# US 27/SR 1 WIDENING AND RECONSTRUCTION

EDS00-0027-00(159)(160)(174) and  
BRN-0027-03(018)  
Early, Clay, and Randolph Counties  
P.I. Nos.: 422230, 422220, 422235, 431531

Value Engineering Study Report  
90% Design Stage

September 2008

174-5

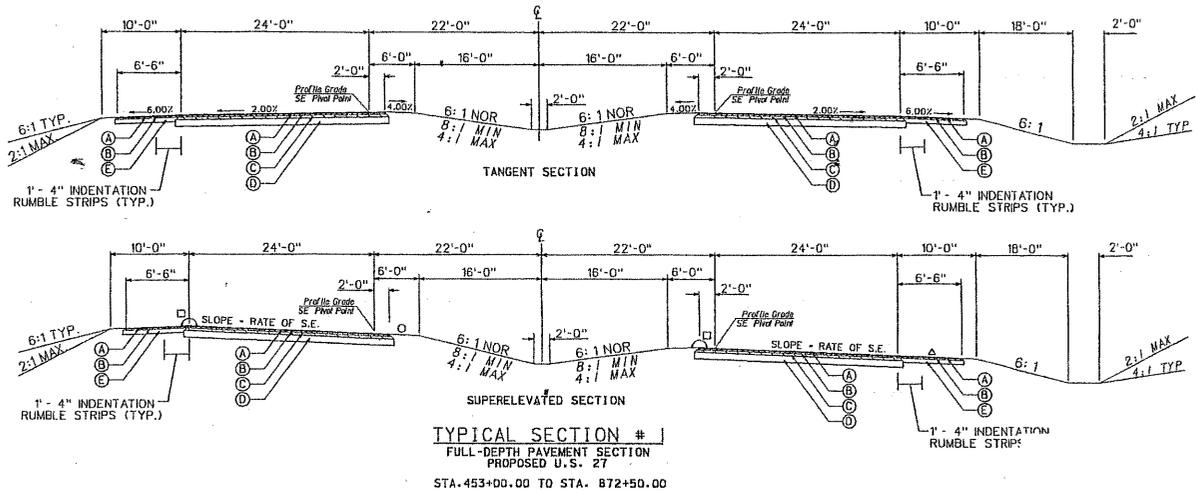
DESCRIPTION: **REDUCE THE MEDIAN WIDTH FROM 44 FT. TO 32 FT.** SHEET NO.: **1 of 5**

DESCRIPTION: **REPLACE THE BOX CULVERT WITH A PRECAST** SHEET NO.: **1 of 4**  
**SYSTEM AT CARTER CREEK – STREAM NO. 12**

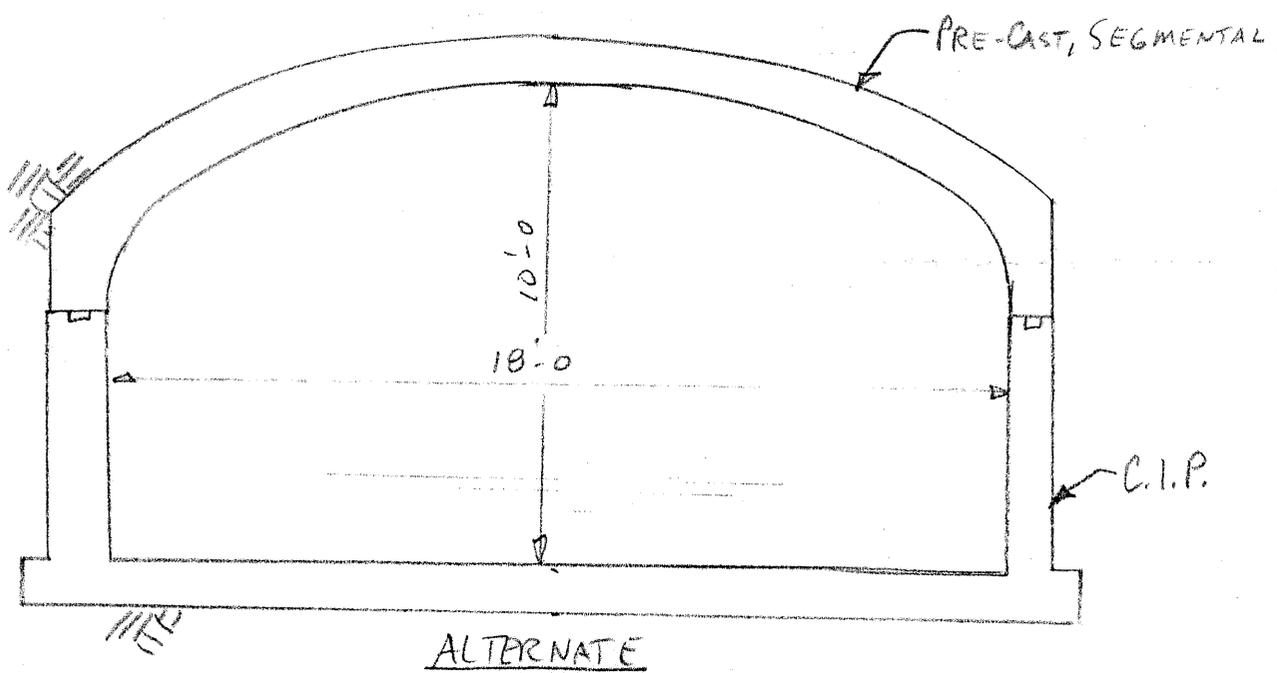
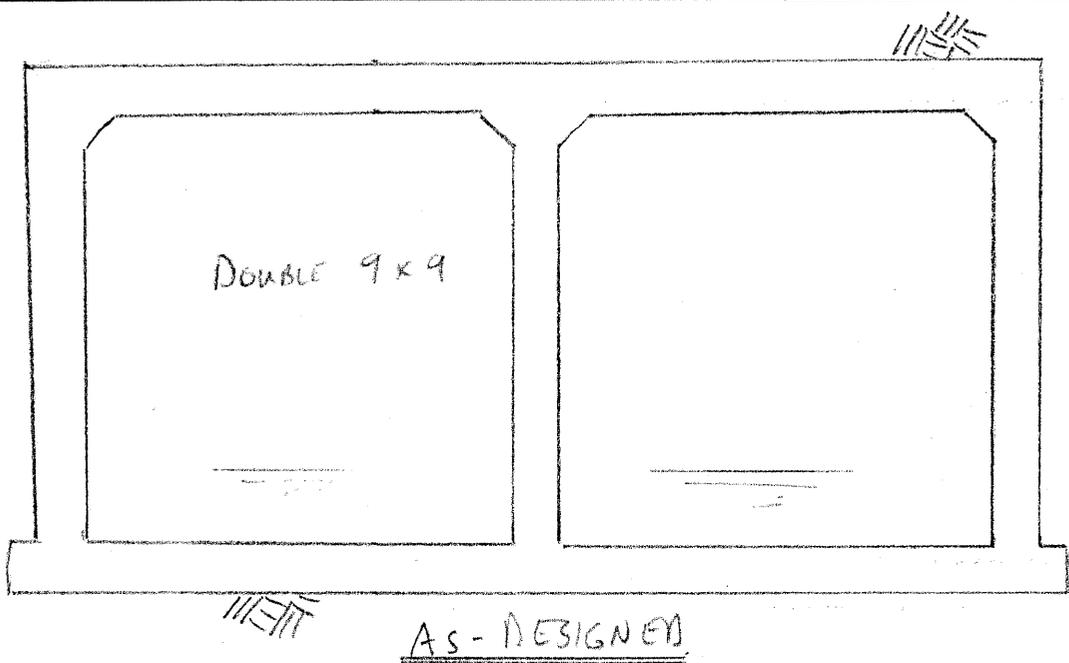
Replace the double concrete culvert with a precast arched single-span structure.

DESCRIPTION: **REPLACE THE BOX CULVERT WITH A PRECAST** SHEET NO.: **1 of 4**  
**SYSTEM AT STREAM NO. 11**

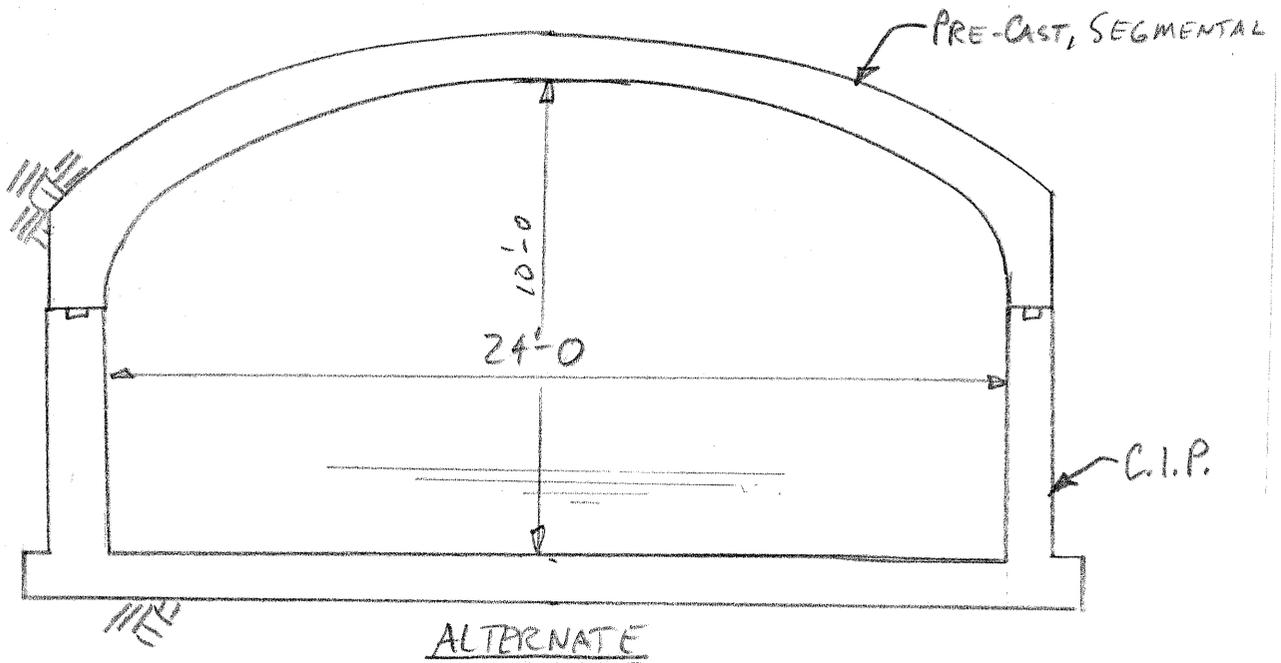
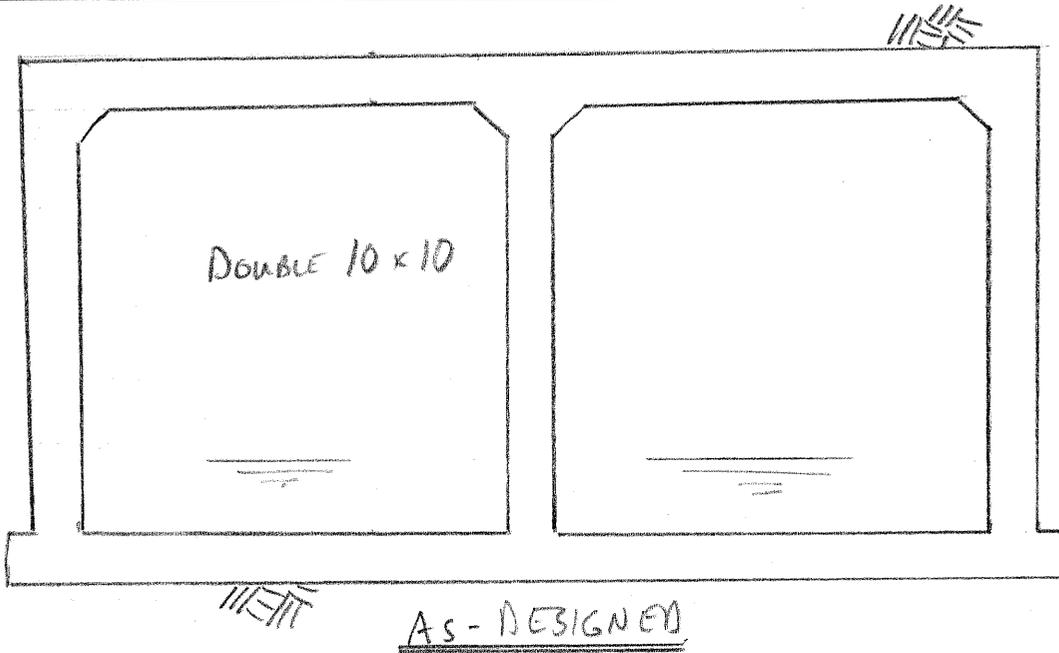
Replace the double concrete culvert with a precast attached single-span structure.

174-16

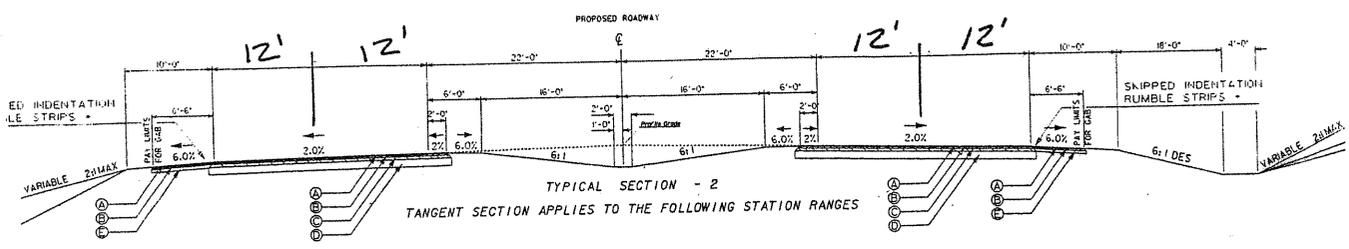
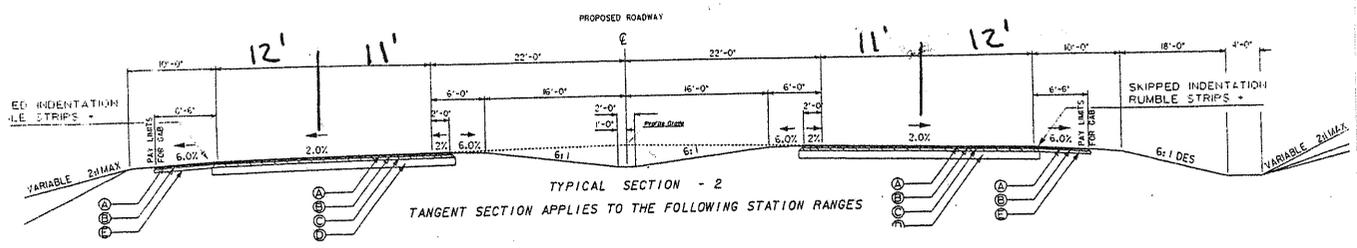
DESCRIPTION: **REDUCE THE INSIDE TRAVEL LANE WIDTH TO 11 FT.** SHEET NO.: **1 of 6**  
**AND RETAIN the 12-FT. OUTSIDE TRAVEL LANES**

159-2

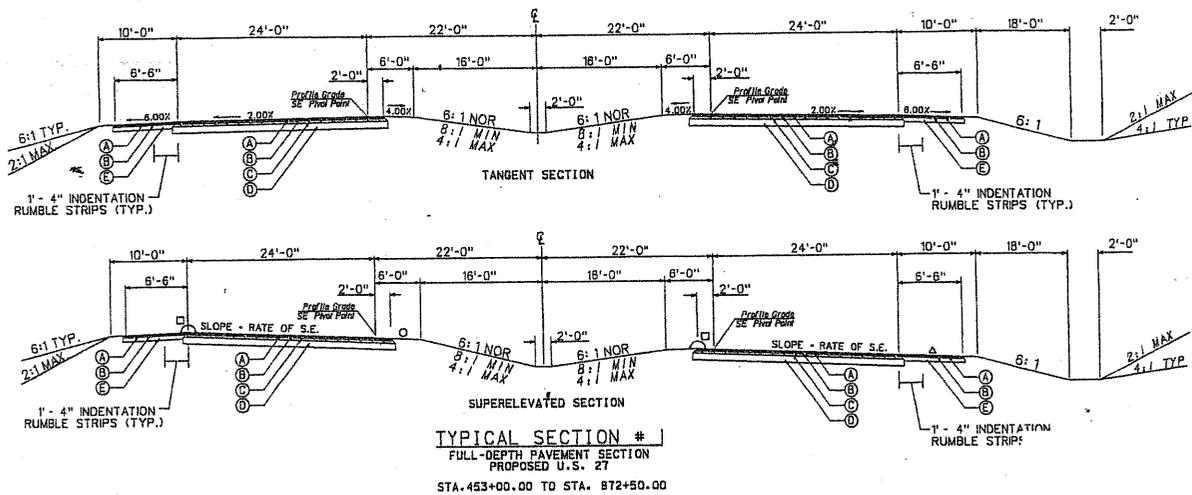
DESCRIPTION: **REDUCE THE MEDIAN WIDTH FROM 44 FT. TO 32 FT.** SHEET NO.: **1 of 4**

DESCRIPTION: **RECONFIGURE THE ALIGNMENT TO CREATE ONE-** SHEET NO.: **1 of 7**  
**WAY PAIRS WITH THE EXISTING NORTHBOUND**  
**ROADWAY**

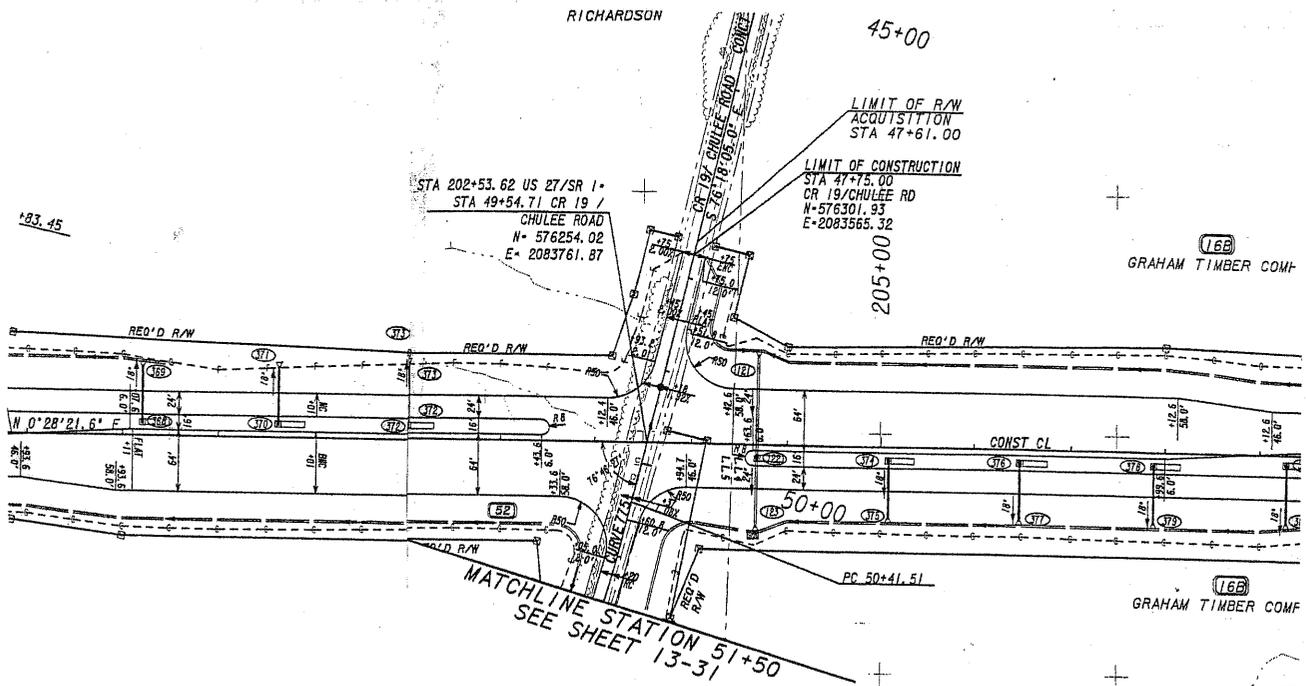
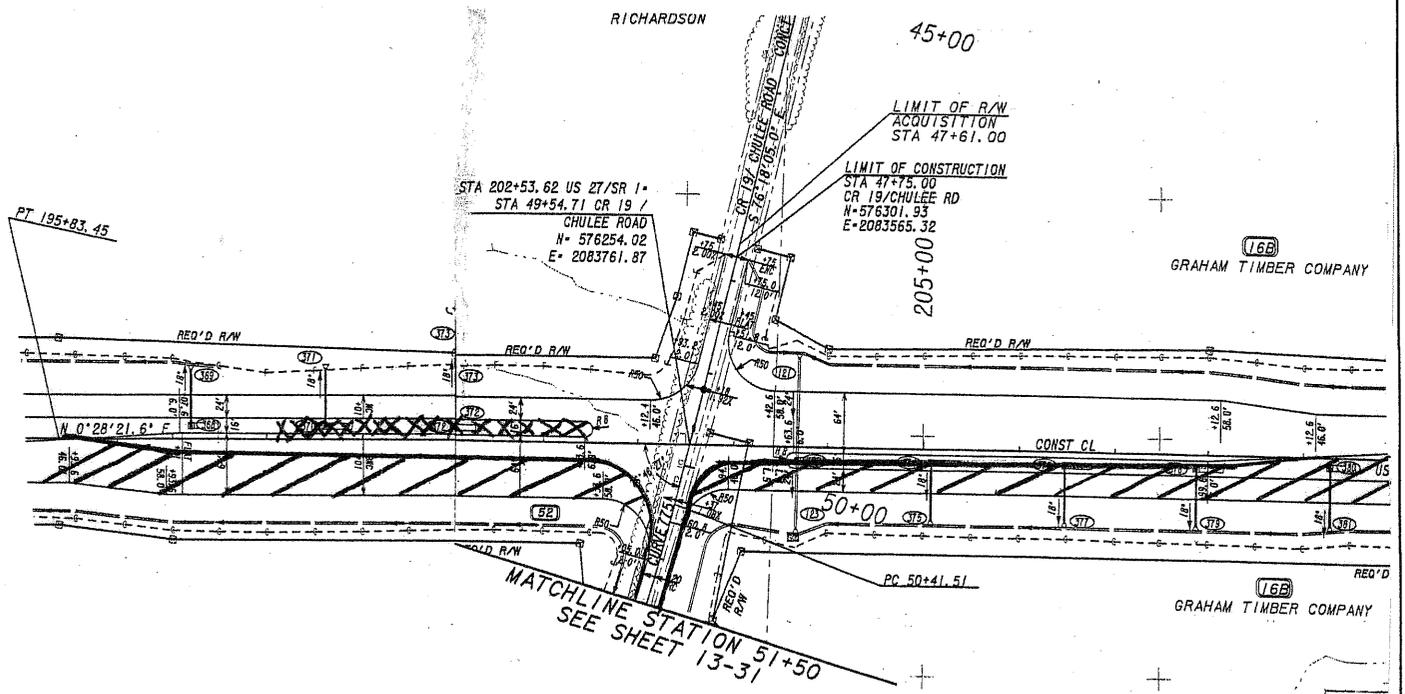
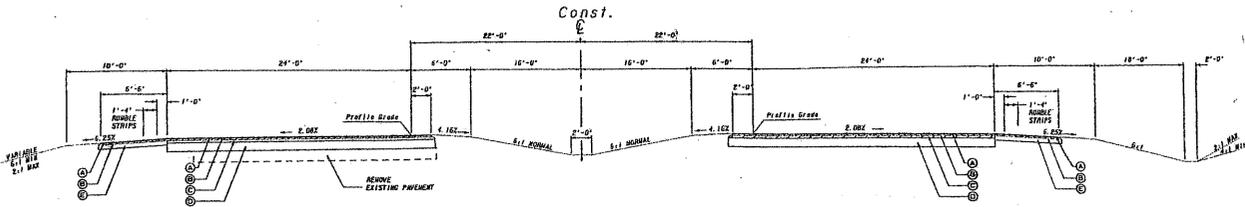
Maintaining the existing roadbed and using it for the northbound traffic maintains the concept of not impacting historic properties. Constructing only the southbound roadway in the bypass alignment saves over \$3 million.

159-11

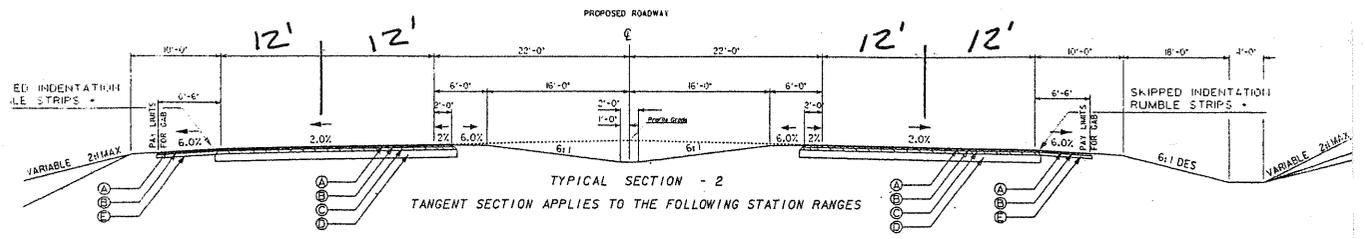
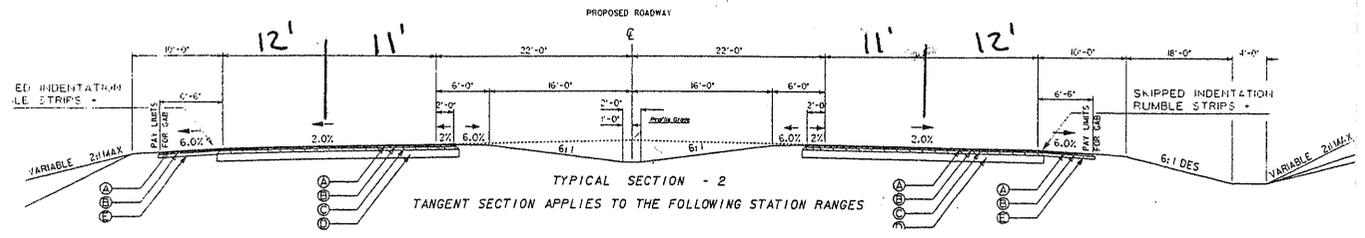
DESCRIPTION: **REDUCE THE INSIDE TRAVEL LANES TO 11 FT. AND** SHEET NO.: **1 of 4**  
**RETAIN 12-FT. OUTSIDE TRAVEL LANES**

160-2

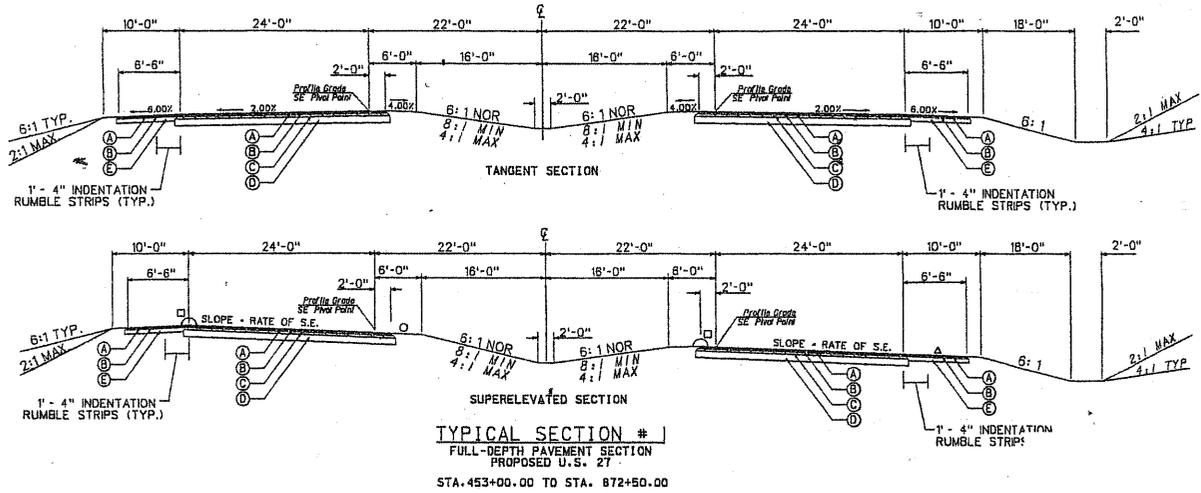
DESCRIPTION: **REDUCE THE MEDIAN WIDTH FROM 44 FT. TO 32 FT.** SHEET NO.: **1 of 4**

160-7

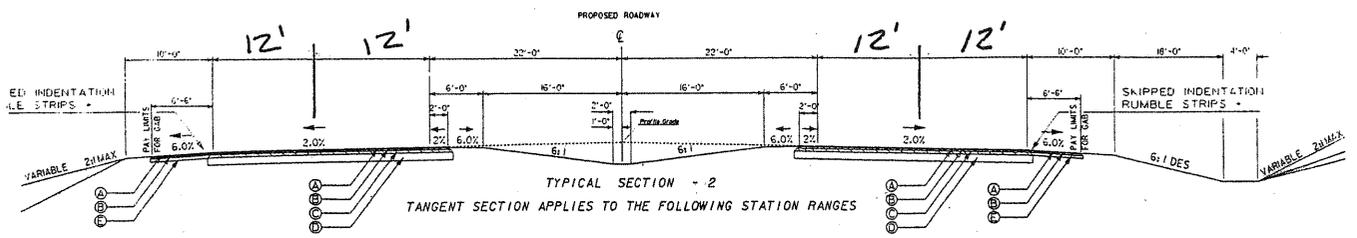
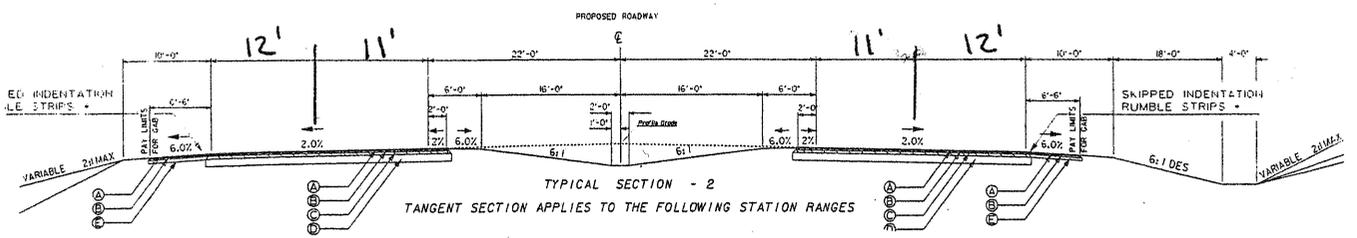
DESCRIPTION: **REDUCE THE INSIDE TRAVEL LANE WIDTH TO 11 FT.** SHEET NO.: **1 of 4**  
**AND RETAIN THE 12-FT.-WIDE OUTSIDE TRAVEL LANES**

160-16

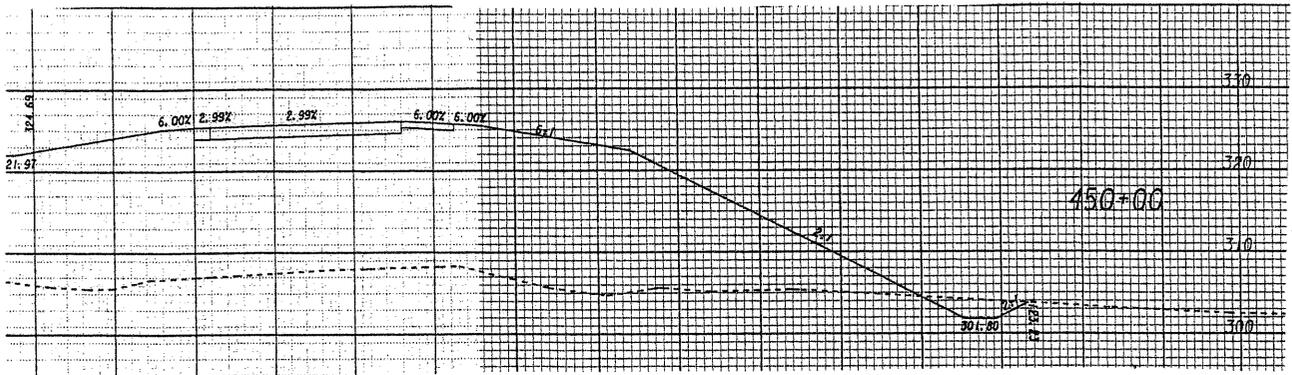
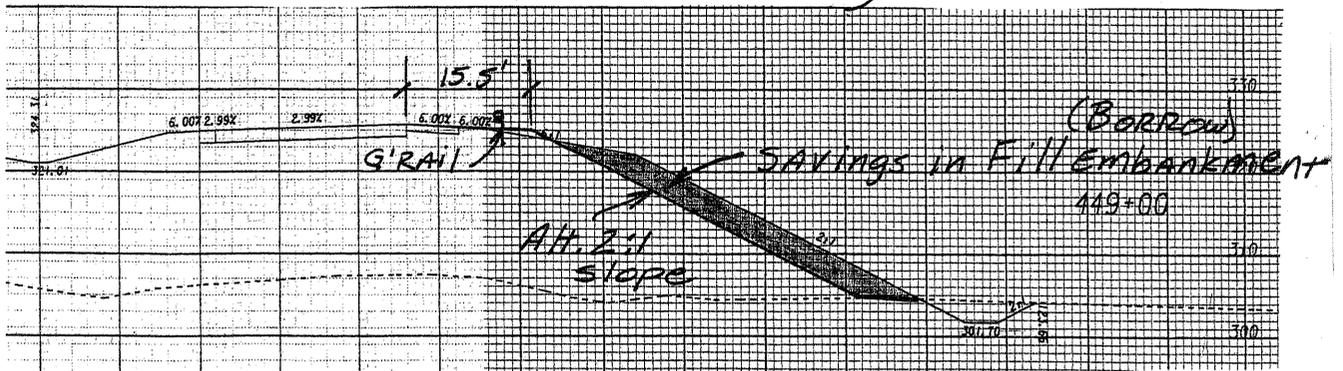
The “barn roof” typical section for fill sections is sometimes used to provide the necessary clear zone distance in lieu of a wider shoulder and guardrail. Since the project requires 365,000 CY of borrow, it may be beneficial to use 2:1 slopes with guardrails to reduce the amount of required fill. It is noted that since borrow on this project is 365,000 CY, the average height of fill needs to be 15 ft. or more to save costs.
